CITY OF CONCORD
New Hampshire's Main Street™
Community Development Department
Planning Division

Staff Report for Planning Board

Project Summary – Major Site Plan and Architectural Design Review

Project: Urgent care clinic (2025-95)
Property Owner: Cafua Realty Trust CXXXIX, LLC
Applicant: Fulmer Lucas and Manchester Health Services, LLC
Property Address: 161 North State Street
Tax Map Lot: 583Z 30

C0.2

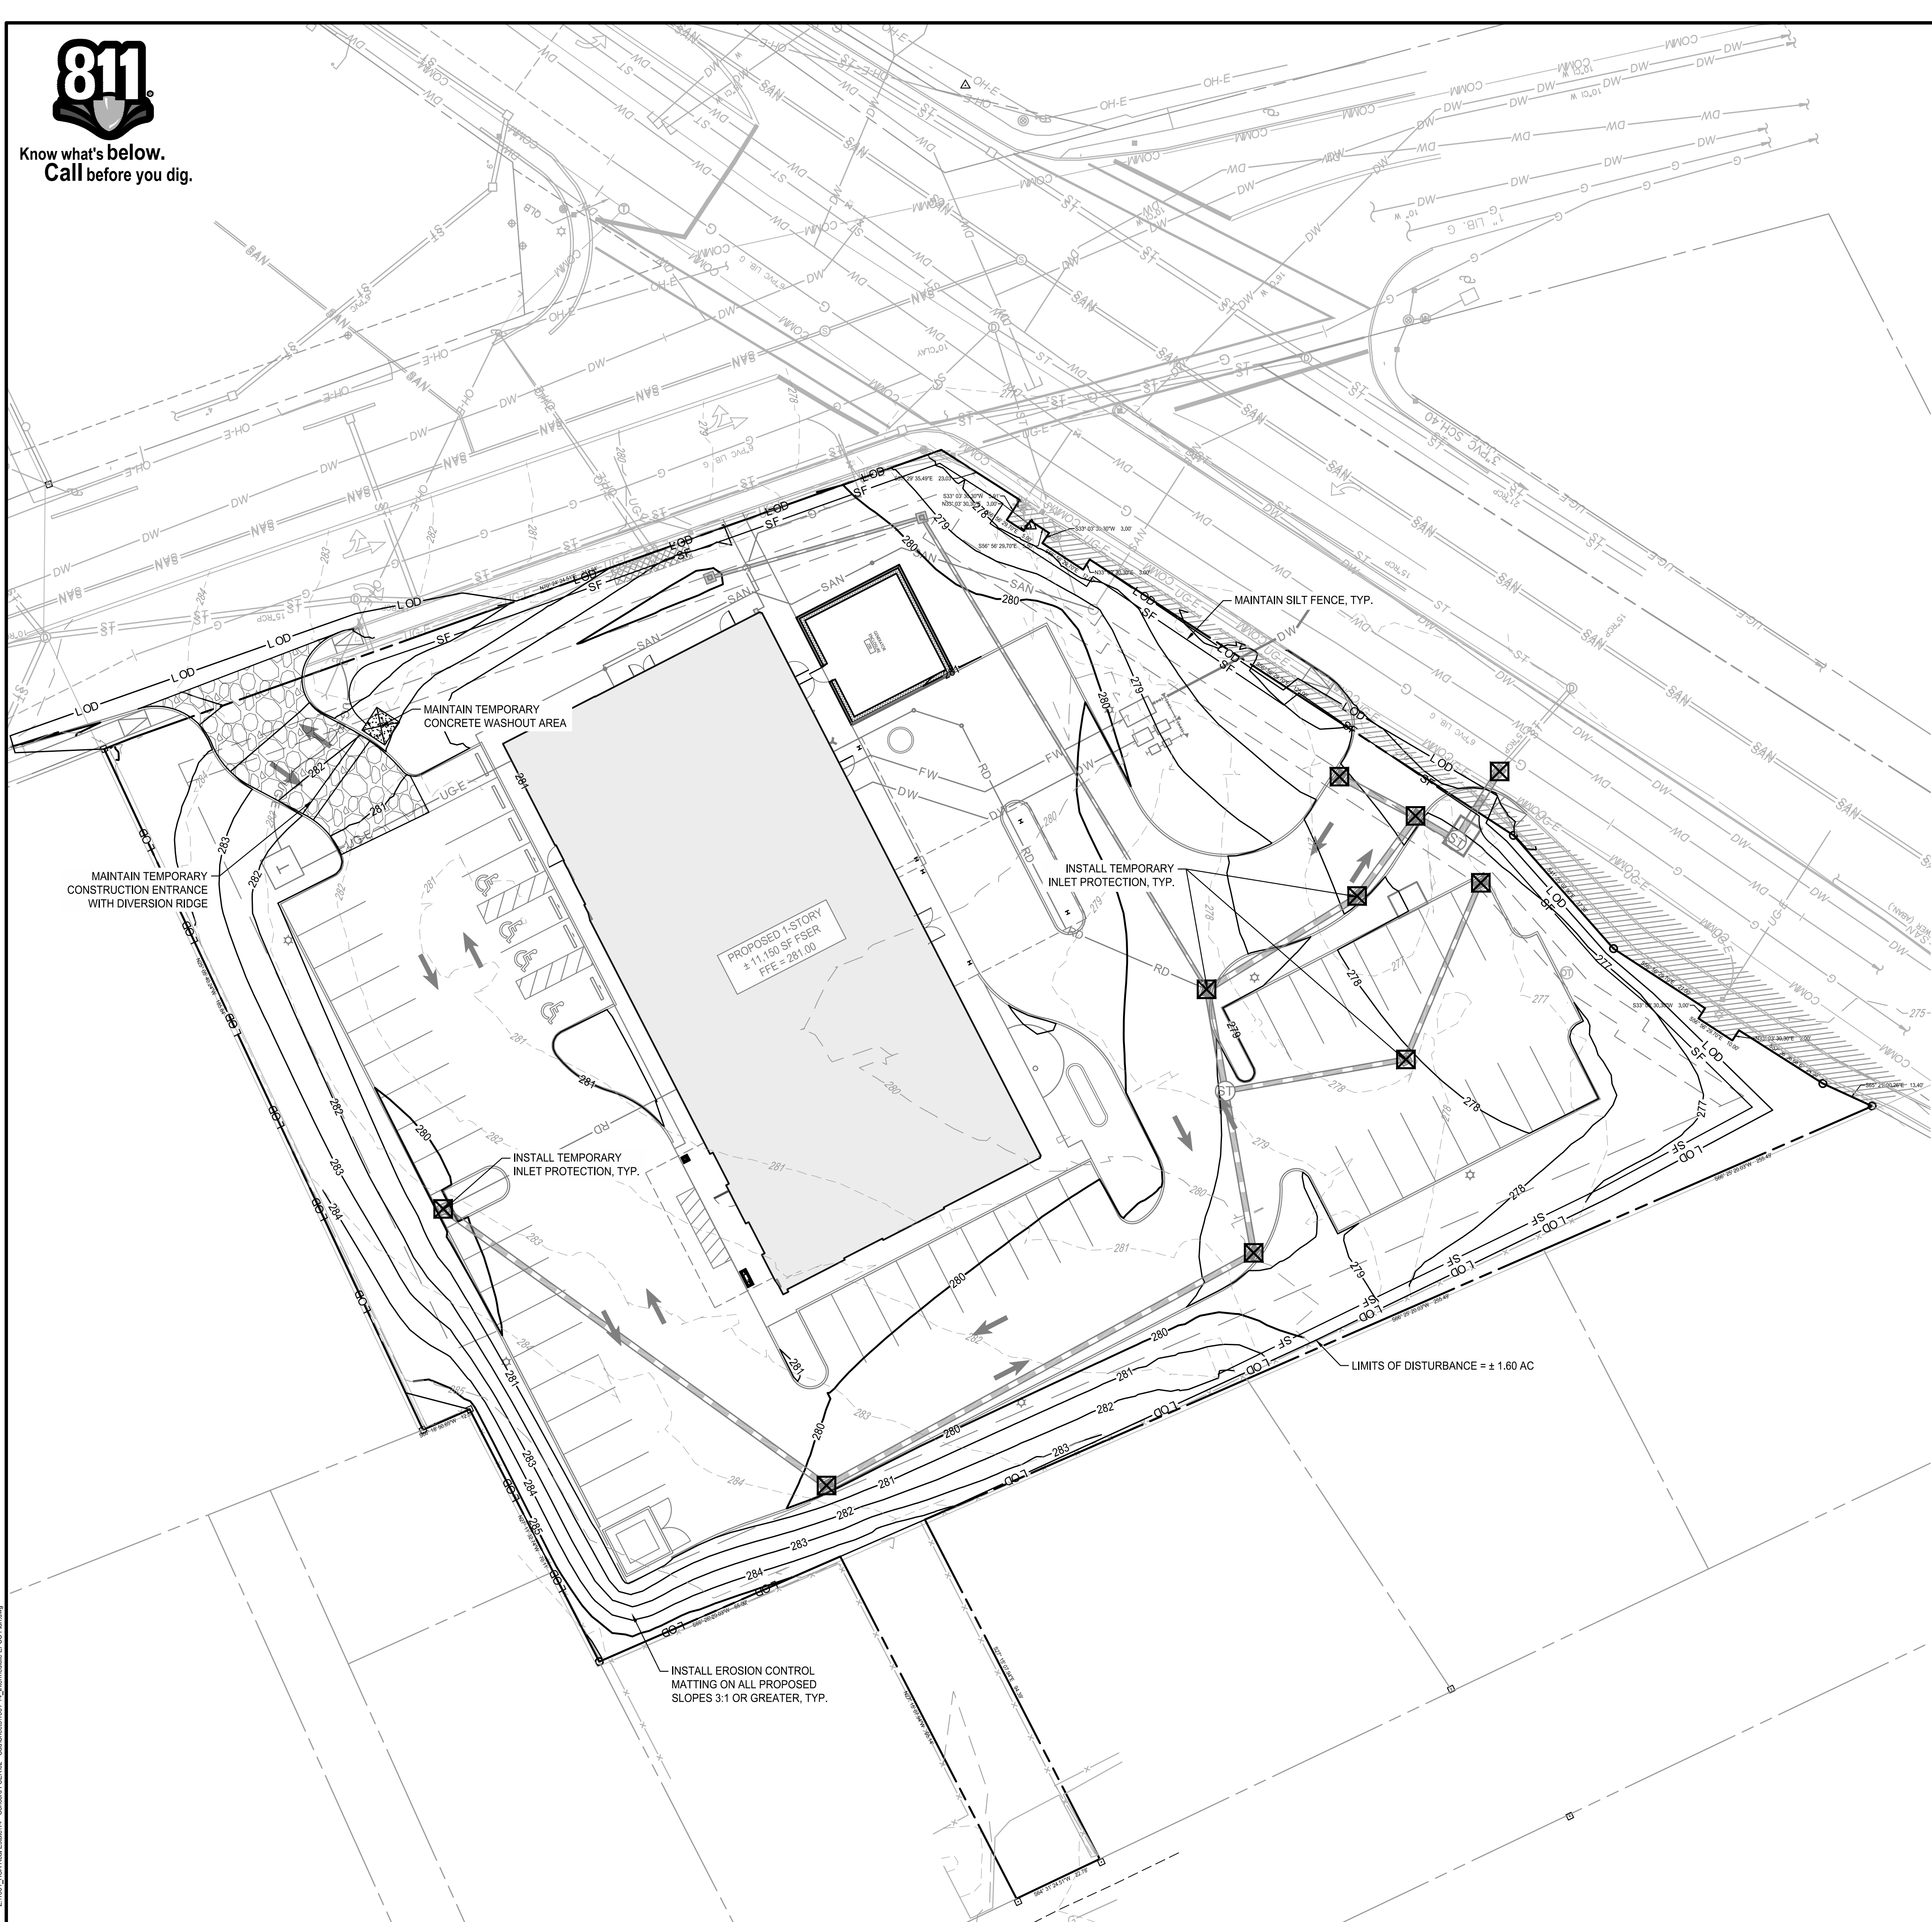
- a. Ensure the Construction Entrance matches the driveway width shown on Sheet C0.3. Also, show silt fence across the North State Street entrance so it will not be used as a construction entrance.
- b. Several Erosion Control features in the legend do not appear on plan view. The Sediment Tube, Rock Check Dam, Diversion Ditch, Erosion Control Matting, and Rock Filter Ring are features that do not appear on this sheet or Sheet C0.3. Please show these features or remove them from the legend.

C1.0

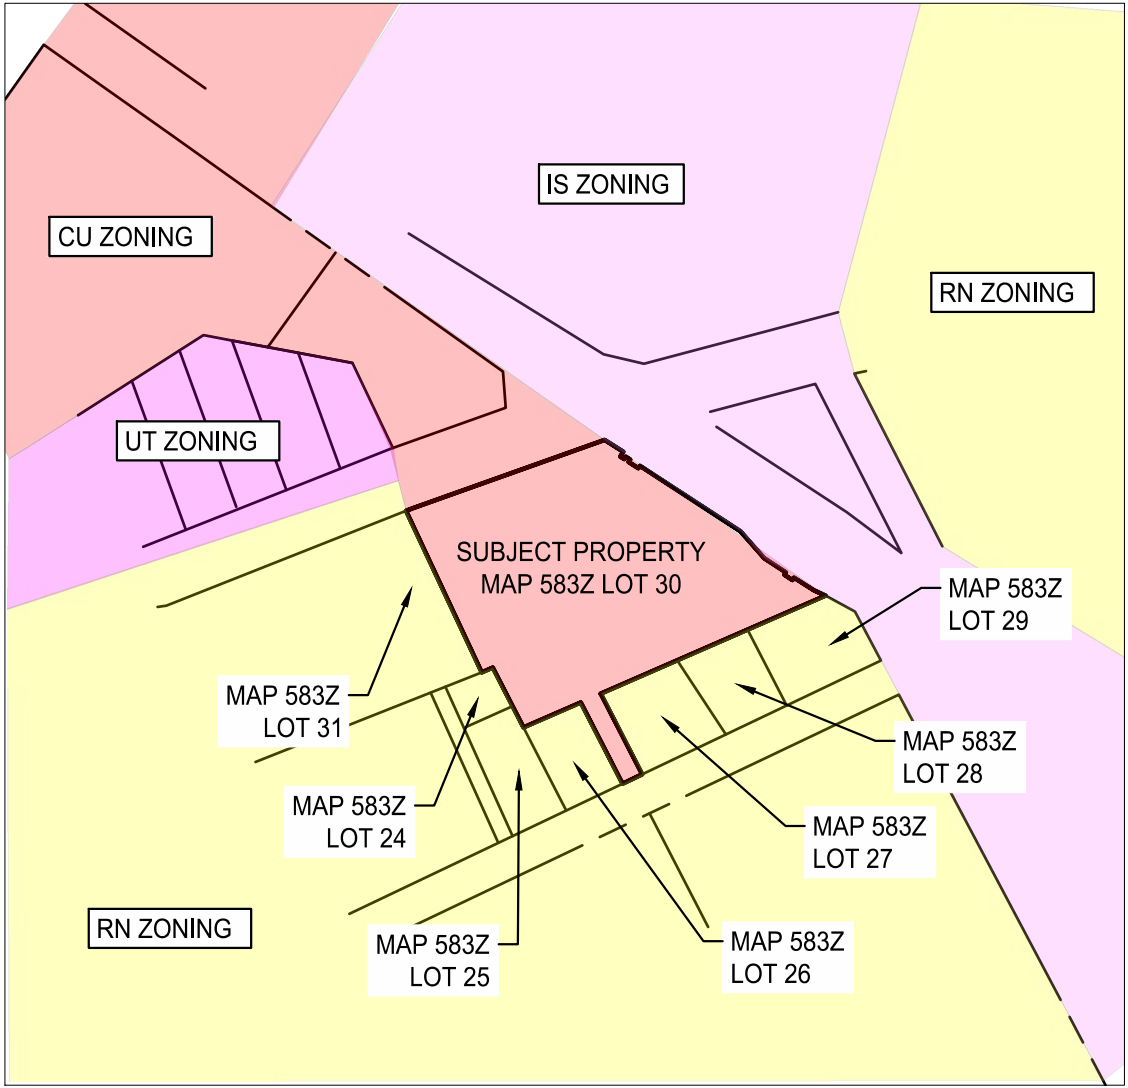
- 3.3 Section 21.05 *Design Standards* requires that all sidewalks, both on the site and off the site, shall be constructed in conformity with the City's Construction Standards and Details, including minimum width of five feet exclusive of curbing, a maximum transverse slope of 2%, sloping towards the street, driveway, or parking area, with all measurements taken from the top of the granite curbing, and an accessible route from the building entrance to a public sidewalk. Add a note to sheet C1.0 and sheet C2.0 stating that all new sidewalks shall comply with the

- a. Please label the locations where curb transition to flush curb begins and ends, pursuant to CSPR 18.19. Add detail C-4 from the City's Construction Standards.

- i. The entrance to the site from Penacook St will be reconstructed/relocated. Per PROWAG, an ADA-compliant handicapped ramp will need to be built on both sides of the drive. Please include details CR-2 and CR-3 from the Construction Standards.
- j. Delete or revise note 15 (per Concord Construction Standard C-4).

- e. Add a note to sheet C1.0 and sheet C2.0 stating that all new sidewalks shall comply with the Construction Standards and Details, including specifically noting that all new sidewalks shall comply with Section 3.02.D and Section 3.03.M, N, and O, of the Construction Standards and Details, shall be a minimum of five feet in width, exclusive of curbing, and shall have a maximum transverse slope of 2%, sloping towards the street, driveway, or parking area. Add a note stating that an accessible route shall be provided from the building entrance to a public sidewalk that meets federal standards for an accessible route to the public way. Revise note 6 on sheet C1.0 to state that all sidewalks shall be at least five feet wide exclusive of curbing. (Section 21.05)

C2.0

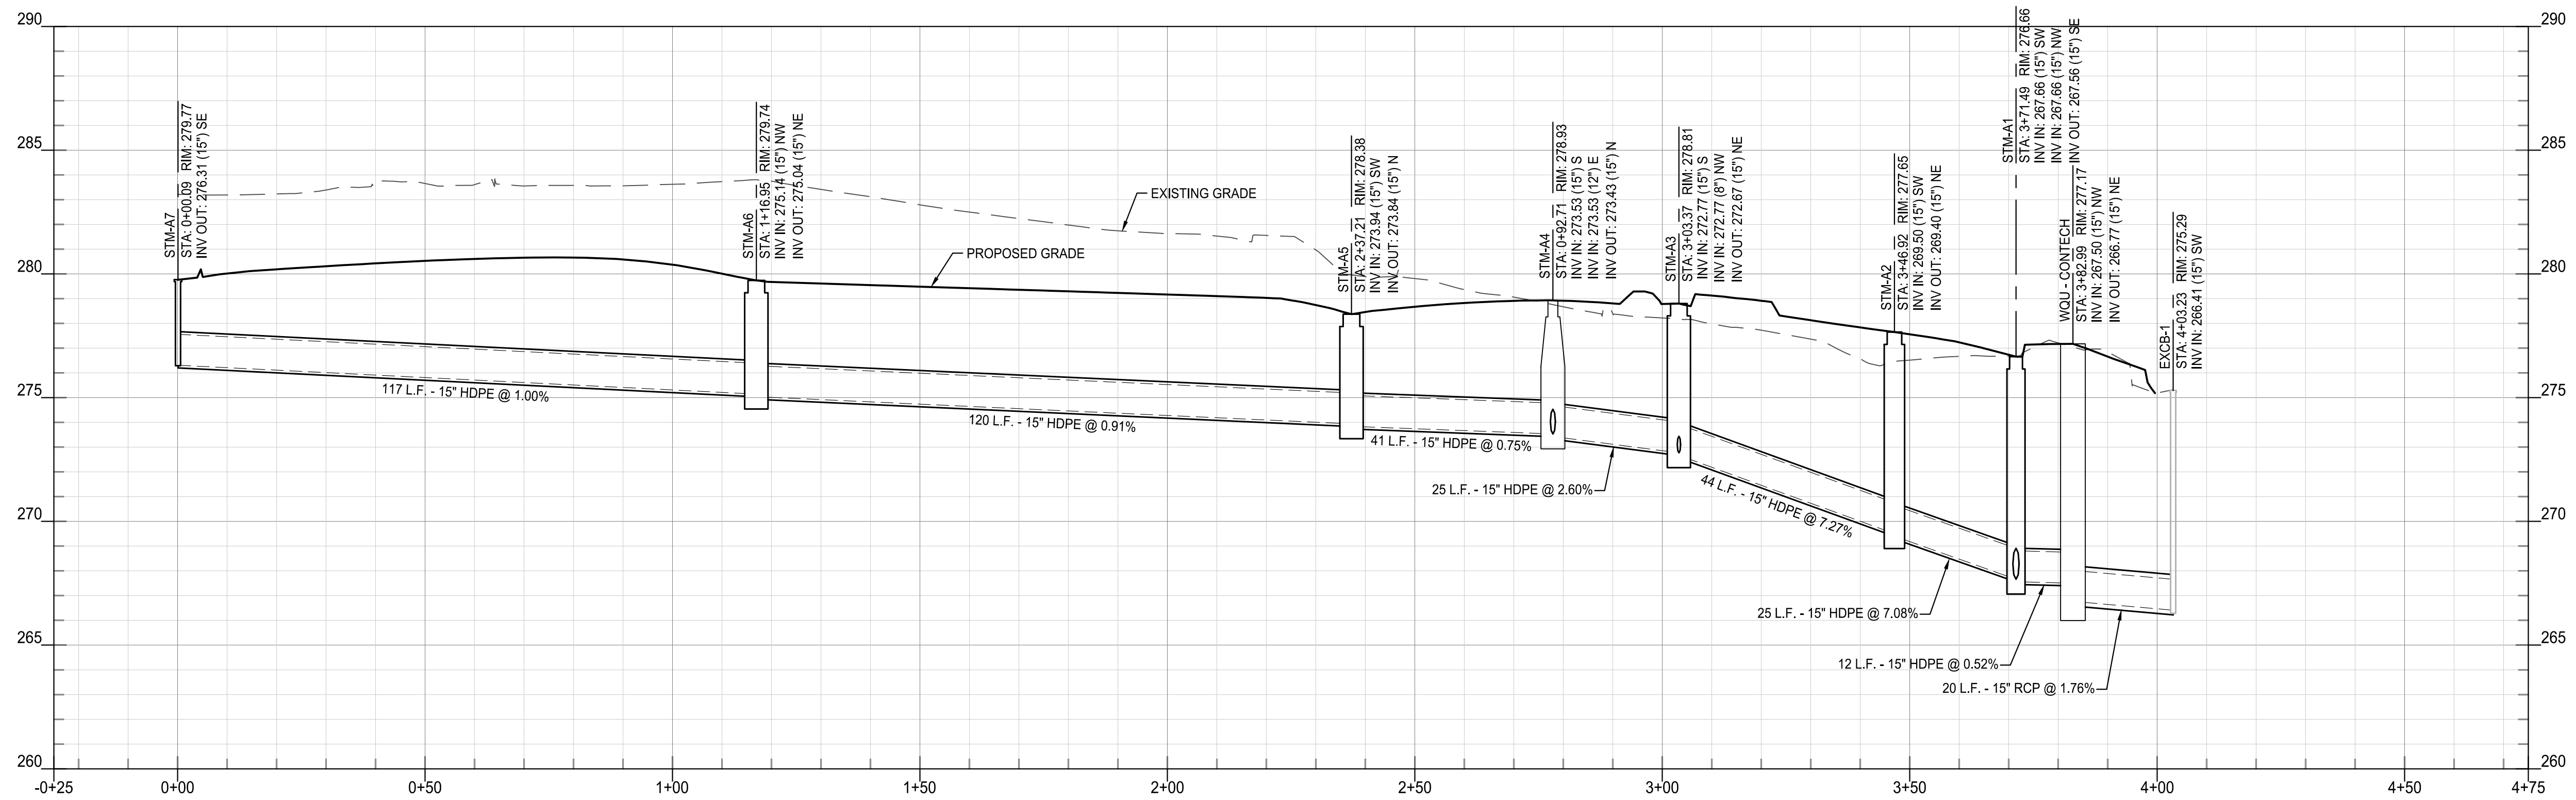
- a. To facilitate final paving, label high and low points, ridge lines, and site slopes on the driveway pursuant to CSPR 16.02(12)(a).
- b. The spot grades show only a 6" curb. Please use a 7" vertical granite curb, pursuant to City of Concord Construction Standards and Details (CCSD) Detail C-1, C-4 and C-5.

- d. Stormwater flowing downhill from Penacook Street shall be directed past the entrance to the site by grading the driveway accordingly. Add spot shots or grade lines and add construction detail D-1 to sheet C4.0.

- f. Structure STM A4.1 shall be a catch basin as depicted on CCCS SD-6.
- g. Grading Plan notes 1 and 17 can be deleted as they do not comply to the City's Construction Standards.
